MONTGOMERY COUNTY HISTORIC PRESERVATION COMMISSION
STAFF REPORT

Address:	7209 MacArthur Blvd., Bethesda	Meeting Date:	2/8/2023
Resource:	Contributing Resource Potomac Overlook Historic District	Report Date:	2/1/2023
Applicant:	Kim & Arthur Newmyer (Robert Black, Architect)	Public Notice:	1/25/2023
Review:	HAWP	Staff:	Dan Bruechert
Permit No.:	1008960 Revised	Tax Credit:	Partial
Proposal:	Window Replacement

Figure 3: The existing window configuration (left) and the proposed (right).

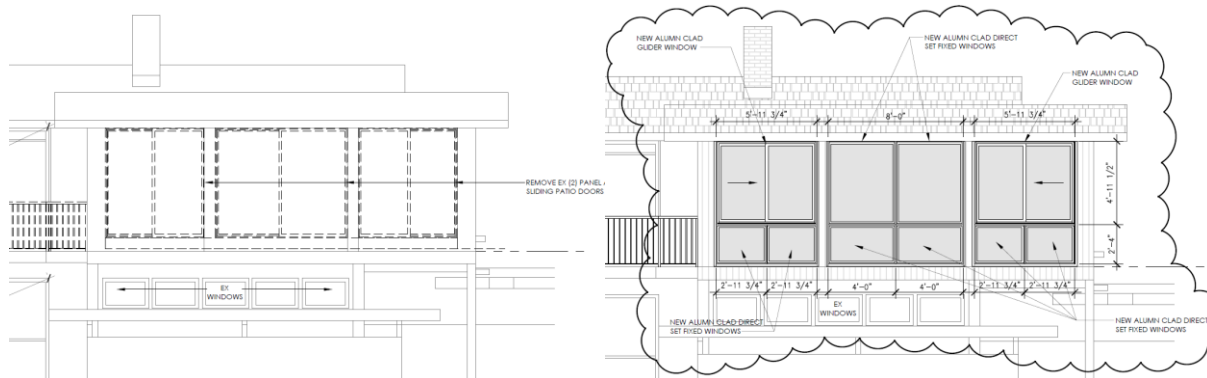
The *Design Guidelines* identify the ‘side gable addition’ as a non-historic feature that is generally compatible with the historic character of the house. This addition captured space from an exterior deck and enclosed it with sliding glass doors that make the space largely open. The applicant proposes to remove the sliding glass doors and install new aluminum-clad window assemblies in the existing openings. The window assemblies have two larger windows set over smaller fixed windows below (see image, below). Some of these window assemblies are entirely fixed, while others have a single slider in the upper section.

Staff finds that the existing sliding glass doors are not original fabric, but are generally compatible with the character of the subject property and the other houses in Potomac Overlook. Staff also finds that the front elevation includes full-height windows that are divided into upper moveable sliders with fixed lower windows. Staff finds the proposed replacement window assemblies are in keeping with the character of the historic windows and are compatible replacements with the non-historic windows under the *Design Guidelines* and 24A-8(b)(2).

Staff recommends that the Commission **approve** the HAWP application under the Criteria for Issuance in Chapter 24A-8(b)(1), (2), and (d), and the *Potomac Overlook Historic District Design Guidelines* having found that the proposal will not substantially alter the exterior features of the historic resource and is compatible in character with the district and the purposes of Chapter 24A;
